Forest Issues Group

RE: Statement of Objections for the Lake Tahoe Basin Management Unit Forest Plan, FEIS, and Draft ROD with recommendations for specific improvements 36 CFR § 219.54 (c). Mr. Randy Moore, Regional Forester, Region-5 PSW, is the Responsible Official.

Figure 1. Spotted owl habitat areas compared to Fire Plan treatment areas. Significant overlap between PACs/HRCAs and areas to be treated in the Fire Plan are indicated by the red arrows. Maps taken from the Fire Plan and the final forest plan for the LTBMU.

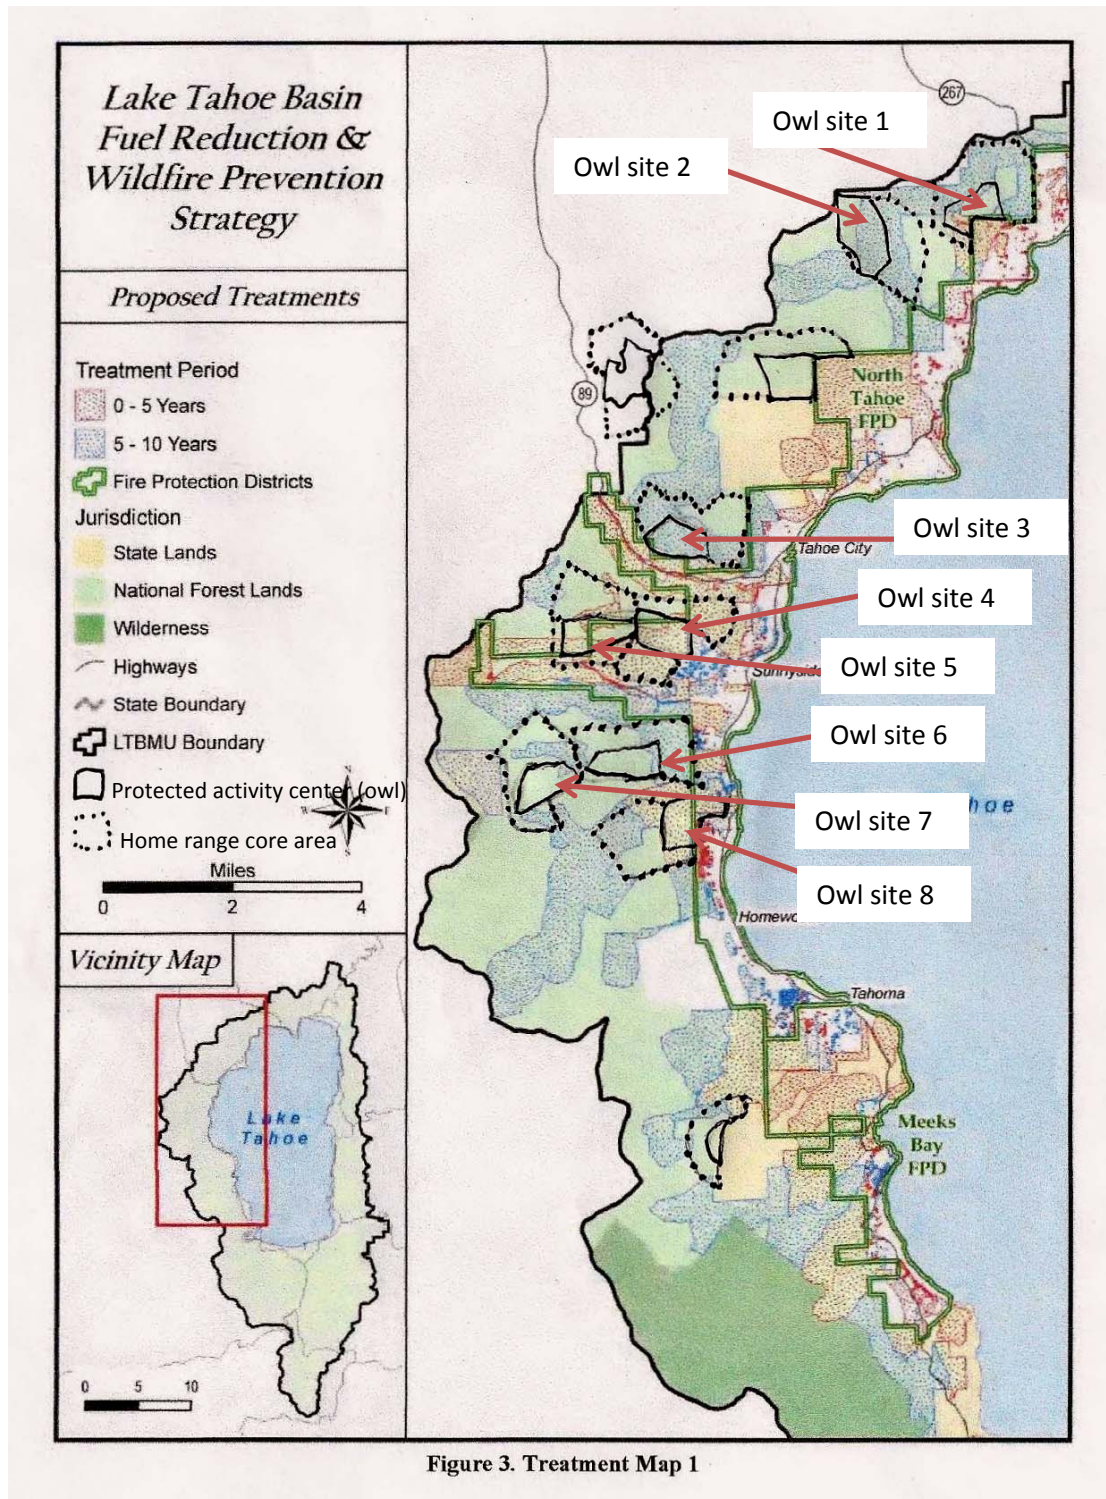
To show how this logging is likely overlapping with critical owl habitat, we compared the area proposed for treatments in the Fire Plan with maps of the PACs and HRCAs for spotted owls provided in the forest plan. As shown below, our comparison suggests that significant overlap exists between areas to be treated under the Fire Plan compared to these sensitive habitat areas for spotted owls.

As can be seen by Figure 1 above, the PAC and HRCA areas for eight owl sites include significant areas proposed for treatment in the Fire Plan. The representation above is just an example of the overlap between the Fire Plan and affected owl sites. There are an additional eleven owl sites that occur on the LTBMU that are not represented here. These too may have significant overlap with treatment areas included in the Fire Plan. As discussed, the 2012 monitoring reports states that the LTBMU has logged approximately 944 acres in PACs in Tahoe since 2004. But this information is not presented or analyzed in any way except through the initial modeling which was then dropped from the analysis at the FEIS stage.

In our view, the studies from Sagehen identify a substantial risk to marten survival and viability from fuel reduction logging, particularly given that the Forest Service lacks information about the location of denning and resting areas, or other aspects of habitat utilization by marten in the Tahoe Basin. Yet the Plan and FEIS provide no analysis of the level of logging that "increases the risk of predation by reducing canopy cover significantly, removing resting and denning structures and escape cover," reduces "the complexity of the understory" or causes habitat fragmentation by producing isolated habitat patches that require energy and risk to travel between. The FEIS instead presents these questions as unknown quantities, even while at the same time the Plan proposes to move forward with considerable logging on the west shore, as described. See Figure 1, above.

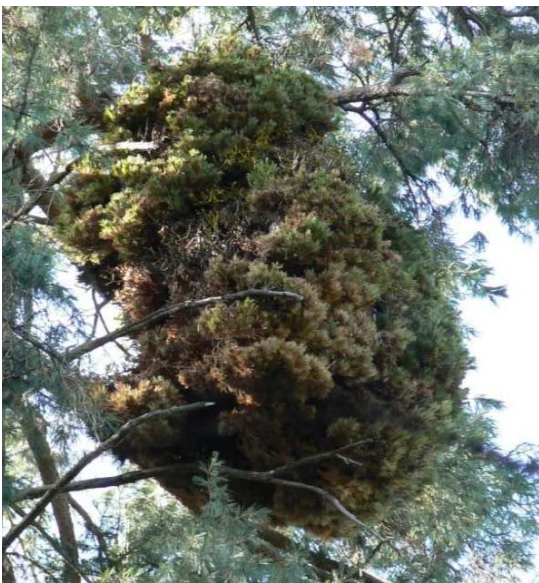
This tree could be targeted for removal under SG 33 (b)

A group of large, old growth trees, including white fir, forms a rare and critical large tree clump, a key element of heterogeneity, that is rare on the LTBMU and across the Sierra Nevada.

SG 33 (c) would allow removal for density reduction

**Forest Plan FEIS - Map 13**

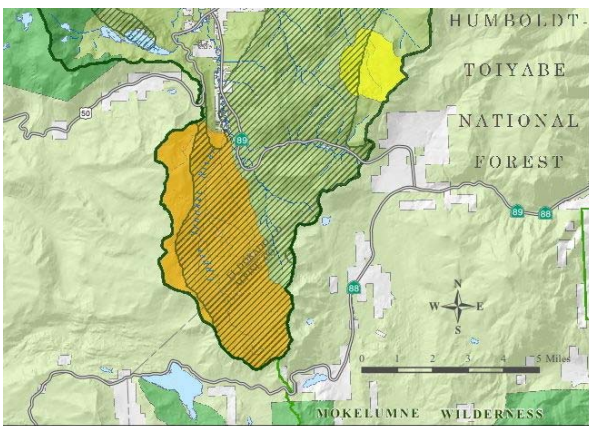
The maps below from the LTBMU FEIS prove that the upper Truckee River and its tributaries share the same outstandingly remarkable fishery (Lahontan Cutthroat Trout) and wildlife (old growth forest habitat for spotted owl and goshawk) values. The same area and streams encompassed on these maps are displayed as wild and scenic river corridors in the proposed wild and scenic river corridors map produced by Friends of the River on the following page.

*This excerpt from Forest Plan FEIS Map 13 shows that the Upper Truckee River and its tributaries provide important habitat for Lahontan Cutthroat Trout (marked in purple).*

**Forest Plan FEIS - Map 12**

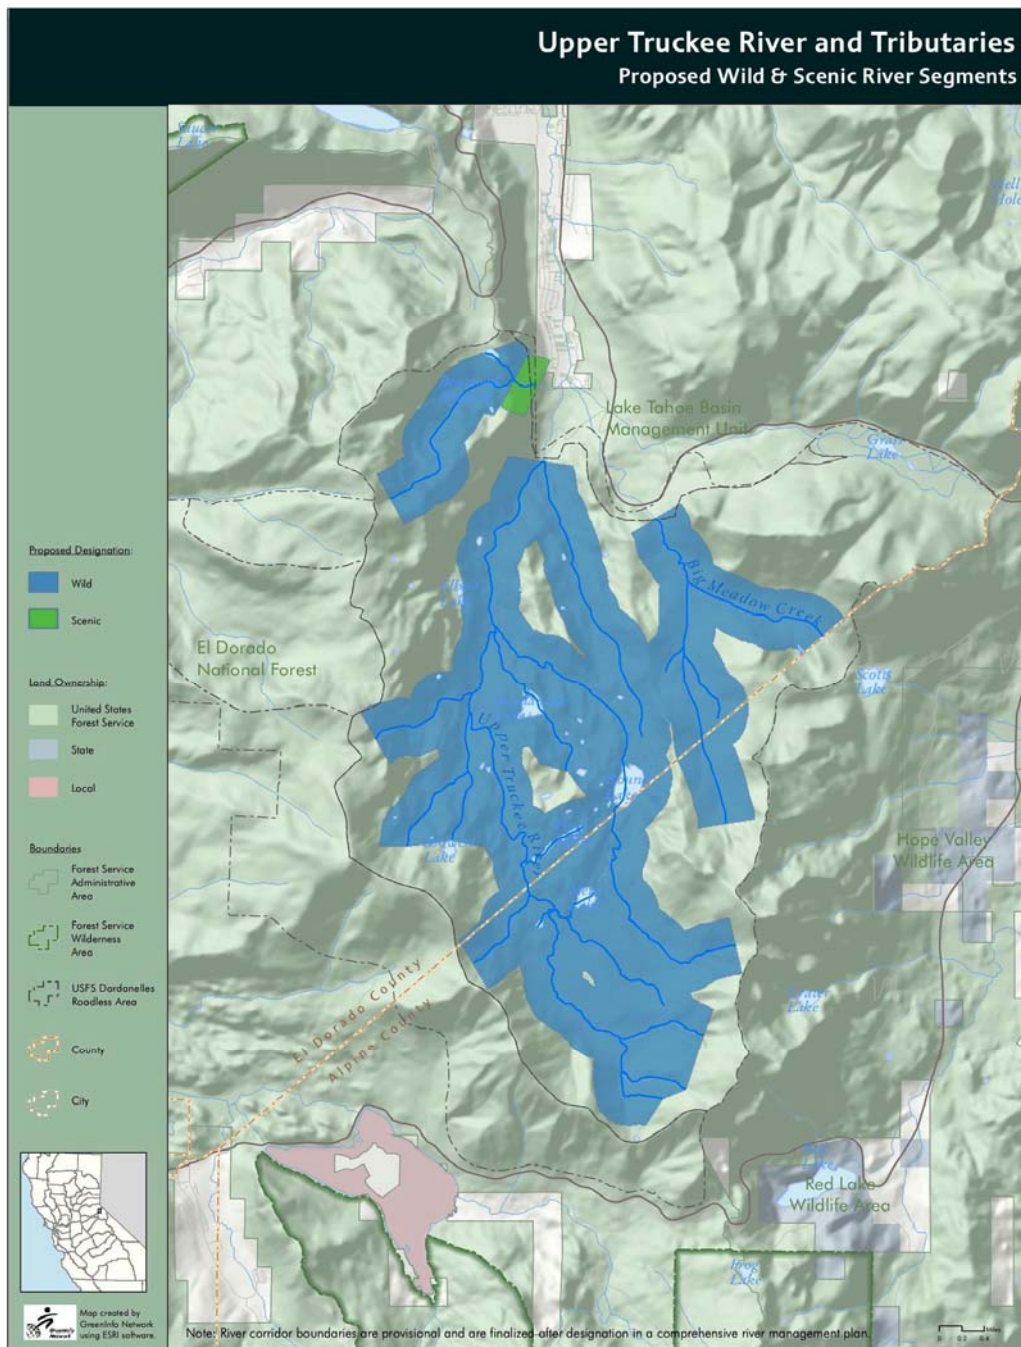
*The excerpt from Forest Plan FEIS Map 12 shows that Upper Truckee River watershed is considered a Critical Aquatic Refuge (marked in orange) and an Old Forest Emphasis Area (marked in cross-hatching).*

Perhaps the biggest failure associated with the suitability assessment of the upper Truckee tributaries is the fact that the public, which originally raised the issue of protecting the upper Truckee's tributaries in hundreds of comments in response to the LTBMU Draft LRMP/DEIS, were excluded from the suitability assessment of the tributaries, even though the FSH requires the Forest Service to collaboratively involve

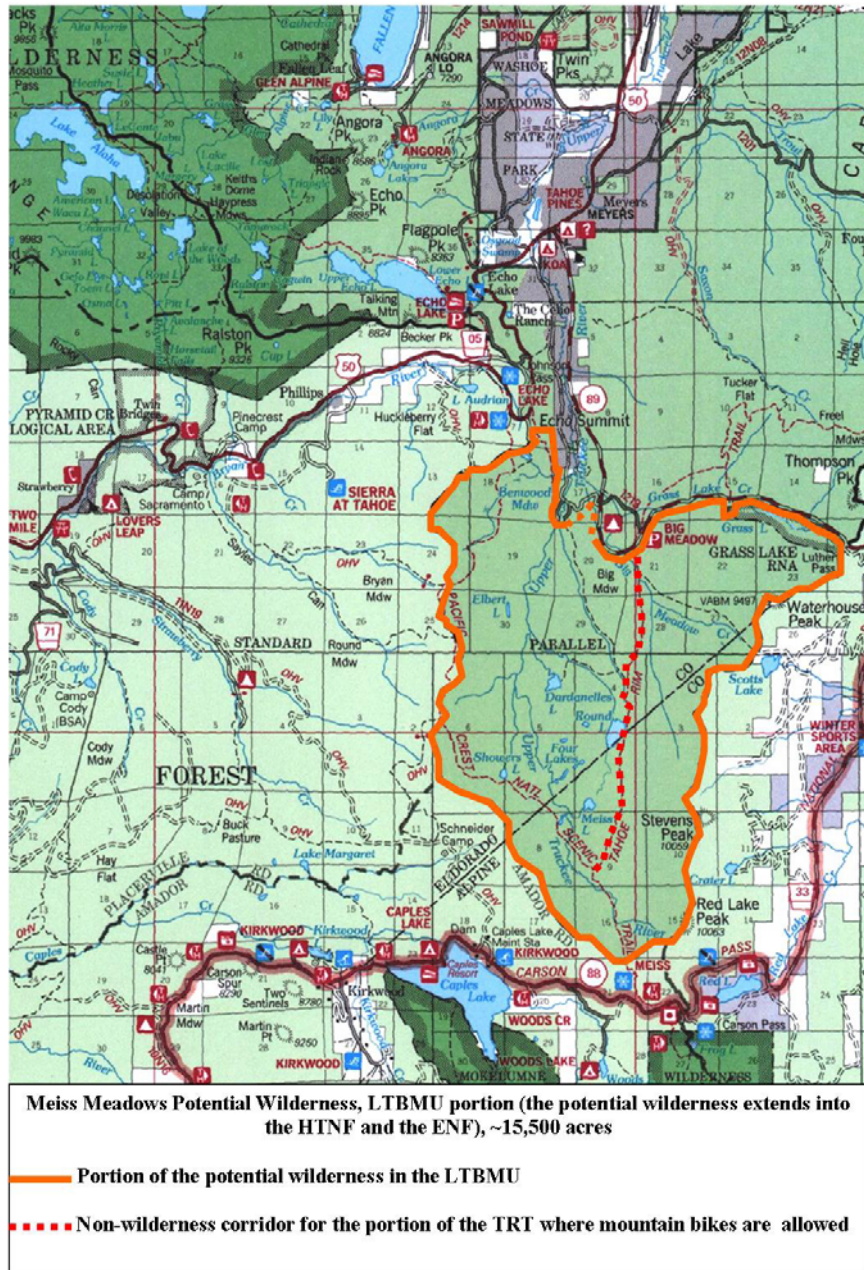
In the alternatives that include wilderness recommendations, the proposals for the Freel Peak IRA and Dardanelles IRA should have been adjusted to exclude the trails where mountain bikes are allowed in order to make them more viable and enforceable. We requested this during scoping and in our comments on the Draft LRMP and DEIS, but the USFS failed to make the effort.

(1) In order to properly recognize and manage all of the roadless lands in Freel Peak, and not just the IRA boundaries identified in the 1970s, we request that the areas shown in blue, below, be recognized as roadless.
